From: Steven Fairchild, HP (steve.fairchild@hp.com)
 Date: 7 March 2005
 Subject: SAS 1.1 External Connector Interoperability

During the last SAS plugfest (November, 2004) sponsored by STA, a couple of interoperability issues were uncovered that are not currently covered by the SAS spec.

Figure 1, Plugfest Configuration

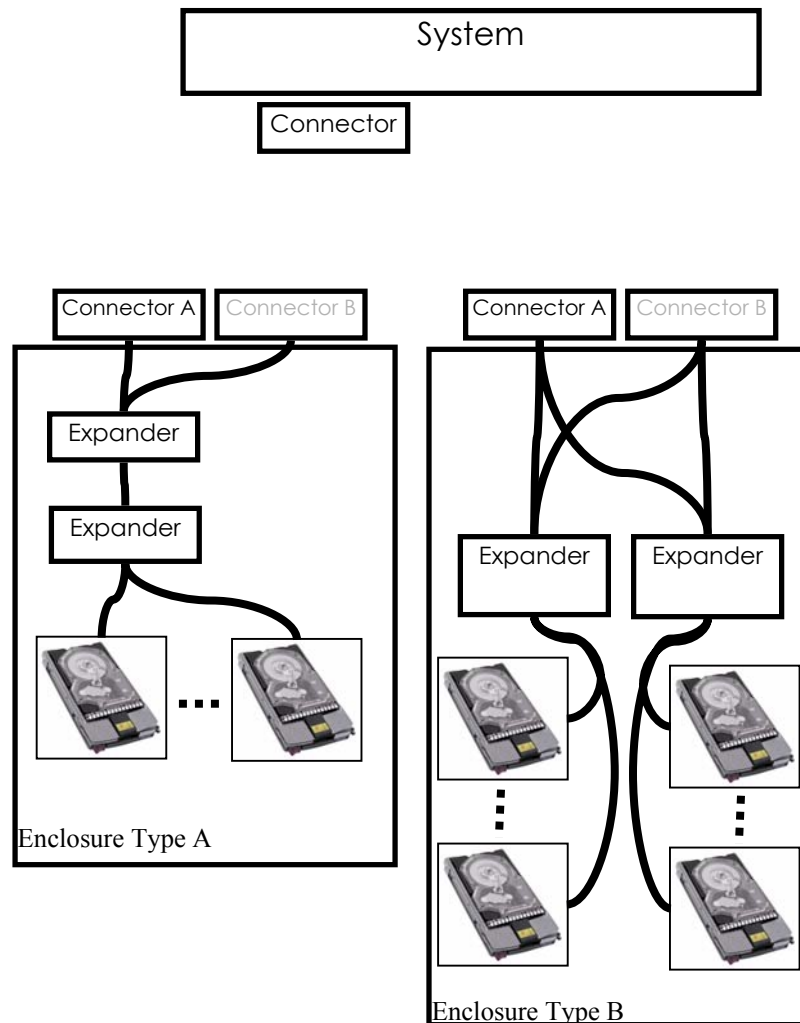
The first issue is an incompatibility that is created when phys routed to an external connector are attached to different expander and/or end devices within the enclosure (see Figure 1).

When the System connector was attached to either of the enclosures (from different manufacturers) the devices were properly discovered. Both enclosures were designed to be “daisy chained” to additional enclosures. When enclosures from the same manufacturer were

“daisy chained” (Enclosure type A to Enclosure type A or Enclosure type B to Enclosure type B) the topology was properly discovered. However when enclosures were “daisy chained” to each other (Enclosure Type A to Enclosure Type B or Enclosure Type B to Enclosure Type A) the topology was not properly discovered.

For “daisy chaining” to function, both enclosures defined one connector (assume Connector A for both enclosures) to use Table routing for the phys in the connector and one connector (assume Connector B for both enclosures) to use Subtractive routing for the phys in the connector. This allows the normal SAS routing behavior of chaining Table to Subtractive to create a large expander device set.

Enclosure Type A chose to attach all of the phys within each of its connectors to a single expander. Enclosure Type B chose to attach the phys within each of its connectors to multiple expanders. These two design choices are what caused the interoperability problem. When Enclosure Type A, Connector B is attached to Enclosure Type B, Connector A (Subtractive phys of Enclosure A to Table phys of Enclosure B) a conflict occurs because the expander attached to Enclosure Type A, Connector B has to different SAS Addresses attached to its Subtractive phys. This is an illegal routing configuration, because the expander attached to Enclosure Type A, Connector B cannot determine where to route its Subtractive addresses. Similar routing issues result from the different connection combinations (see Table 1).

From Table 1, the only legal connection Enclosure A, Connector A attached to Enclosure B, connector B had a problem due to a design decision based on the assumption that a connector would only present a single SAS address if it was attached to an expander.

To resolve this interoperability issue, HP would propose the following text (in blue) be incorporated in SAS 1.1;

The pins of an external receptacle connector shall be attached to only one expander device (see 4.1.5), with the phys attached to the pins representing a single expander port (see 4.6.2).

Figure L. 2, Enclosure Out Port SAS Icon for External Receptacle Connections to Expander Ports with Table routing attribute

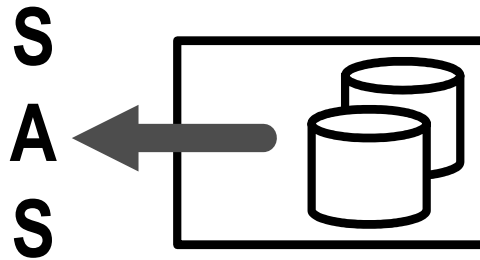
Editor's Note: the import of the icon into the word document changed the end point of the arrow from square to round. The preference is for a square endpoint.

Figure L2 shows an enclosure out port SAS icon that should be affixed near an external receptacle connector for an expander port with the table routing attribute.

Figure L. 3, Enclosure In Port SAS Icon for External Receptacle Connections to Expander Ports with Subtractive routing attribute

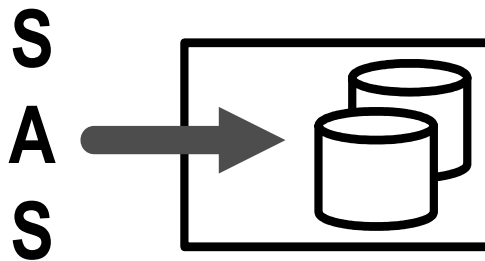
Editor's Note: the import of the icon into the word document changed the end point of the arrow from square to round. The preference is for a square endpoint.

Figure L3 shows an enclosure in port SAS icon that should be affixed near an external receptacle connector for an expander port with the subtractive routing attribute.

Figure L. 4, SAS Icon for External Receptacle Connections on cables that may be attached to End Devices or Expander Ports with Table routing attribute

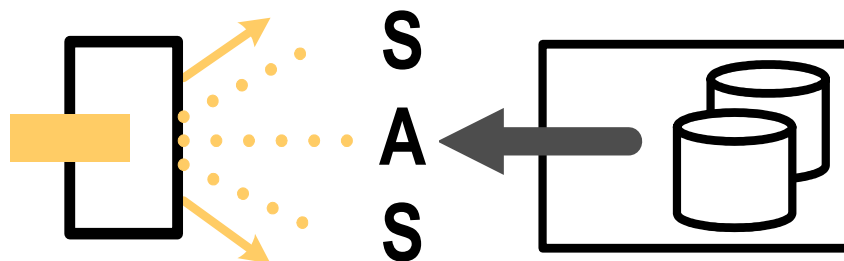
Editor's Note: the import of the icon into the word document changed the end point of the arrow from square to round. The preference is for a square endpoint.

Multiple SAS icons should be located on cables that attach to SAS devices. Figures L4, L5 and L6 show the placement of combinations of SAS icons on cable external receptacle connections. Cable ends should be identified with different icons (e.g. use the enclosure in port icon on one end of a cable and use the enclosure out port icon on the other end of a cable). The SAS icon for external receptacle connections to end devices may appear at both ends of a cable. Like icons indicate the associated connectors should be attached.

Figure L. 5, SAS Icon for External Receptacle Connections on cables that may be attached to End Devices or Expander Ports with Subtractive routing attribute

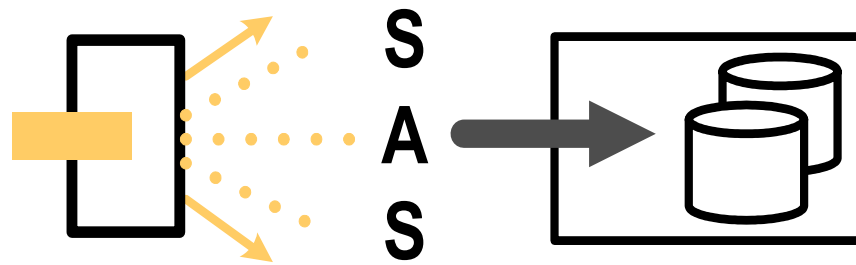
Editor's Note: the import of the icon into the word document changed the end point of the arrow from square to round. The preference is for a square endpoint.

Figure L. 6, SAS Icon for External Receptacle Connections on cables that may be attached to End Devices or Expander Ports with Table or Subtractive routing attribute

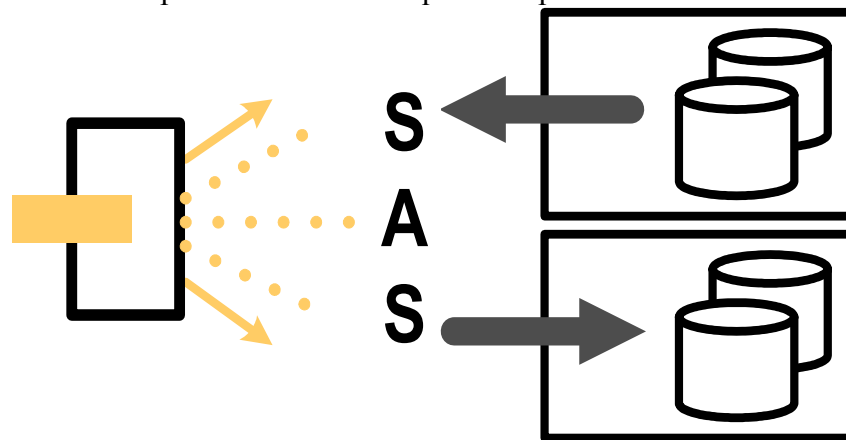
Editor's Note: the import of the icon into the word document changed the end point of the arrow from square to round. The preference is for a square endpoint.
